Docket Item # 11
BAR CASE # 2016-0274

BAR Meeting
September 7, 2016

ISSUE: Replacement Street Lights in the Alexandria Historic Street Light District

APPLICANT: City of Alexandria, Department of Project Implementation

Figure 5. Illustration of comparative light color for LEDs at different temperatures. The 2700K represents the warmest light while higher values result in whiter and bluer light.

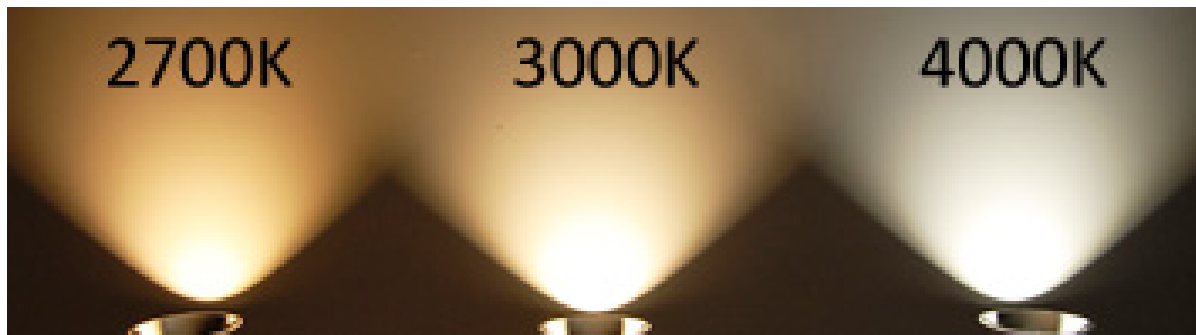
However, the color and character of the illumination is before the BAR. LED technology is continually improving, and it is anticipated that newly available 2700K bulbs would produce a warmer and softer light than the mock-up (see Figure 5) though they are more expensive, use more energy and have a shorter life. Staff recommends that the BAR establish illumination levels and intensity with final approval by BAR staff in the field in order to ensure that the most compatible light color and intensity be employed which also meets public safety requirements.

Staff recommends approval of the new Alexandria Historic Street Light with final light color and ladder bars/banner holders to be approved in the field by BAR staff prior to installation.
